REMARKS

A. Overview

Claims 1-89 are pending in the present application. Applicant's prior response was intended to advance prosecution by placing the claims in what were indicated to be allowable form. Apparently the finding has been rescinded, although no reasoning is provided in the present action.

FIG. 6A

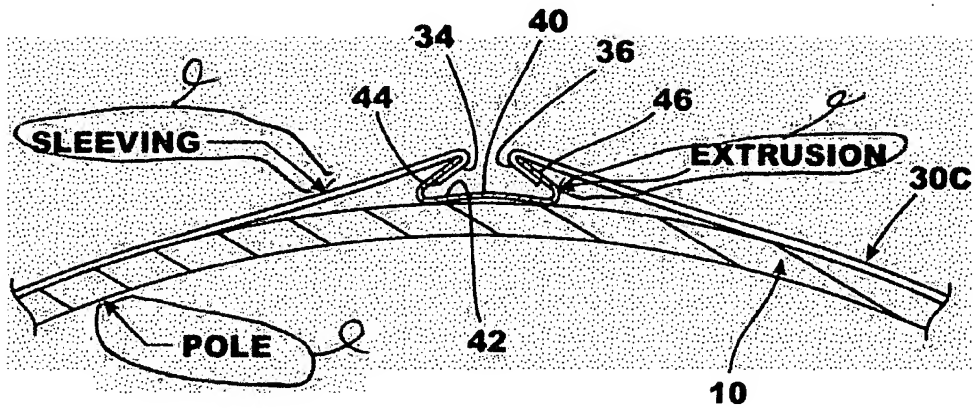
Objection has been made to having text within the drawings. This objection is respectfully traversed. It is submitted that the text is minimal and relates to either dimensional characteristics or aids an understanding of the structure illustrated in the drawings. However, to resolve this issue, accompanying this response are replacement sheets of drawings with the text removed. Also attached are those same sheets with red-lining indicating the changes. Approval of these changes is respectfully requested.

It is noted that additions to the Specification of pages 5-6 have been made which essentially take the content of the text removed from the drawings and place it in the Specification. No new matter is added.
